# 1955 Corvette: Service Bulletin: Hard Shifting

<b>SUBJECT:</b> HARD SHIFTING - 1955 MODEL PASSENGER CAR 3-SPEED TRANSMISSION	<b>BULLETIN No.</b> DR #236  <b>SECTION</b> VII
<b>TO:</b> ALL CHEVROLET DEALERS	January 9, 1956
<p>In cases where hard shifting on 1955 Passenger Models with 3-Speed Transmission is experienced in high frequency shifting operations due to malfunction and/or wear of gearshift controls and butting of transmission gears, the condition may be reduced by installation of a Transmission Control Conversion Kit and three new type transmission gears.</p> <p>The new transmission gears which have more tooth chamfer entered production about July 5, 1955.</p> <p>The revised transmission controls entered production beginning with 1956 Model and the Control Conversion Kit has modified parts for use on 1955 Models.</p>

FIGURE I

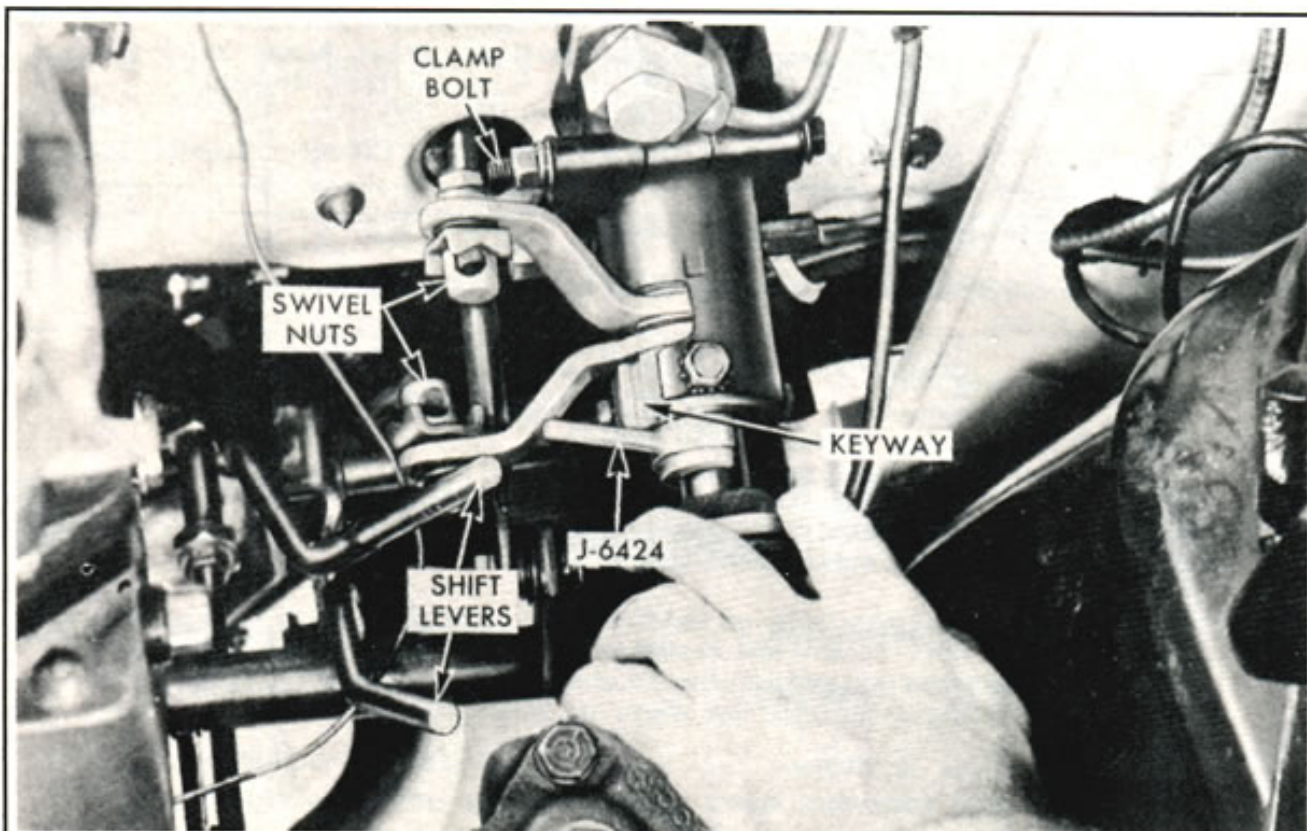
13. Insert gearshift rod ends in swivels - transmission must be in neutral detent in both ranges. Do not tighten.
14. Install alignment gauge J-6424 inserting side stamped "STD" between steering mainshaft and shifter tube in key area. This sets the required 1/16 eccentricity in proper relation to the key on shifter tube. See figure 1.

FIGURE 2

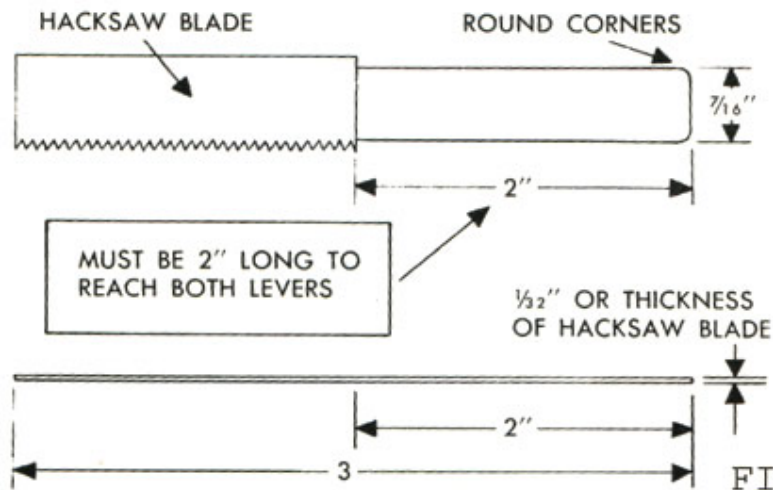
- c. Remove alignment gauge.
16. Make and insert special blade gauge, see figure 2, thru adjusting ring slot, lower levers and gate washer. Tighten swivels on gearshift rods while holding downward lightly on lower levers. Transmission must be in neutral detent at this time.

FIGURE 3

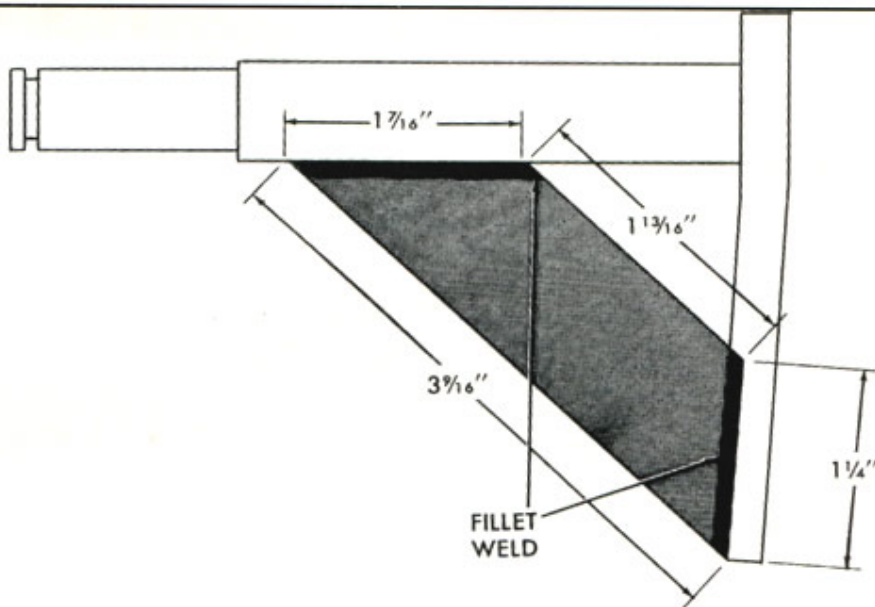
Further improvement of shifting can be made by reinforcement of transmission control rod idler lever support located on left frame rail under toe pan to reduce its deflection. See figure 3.
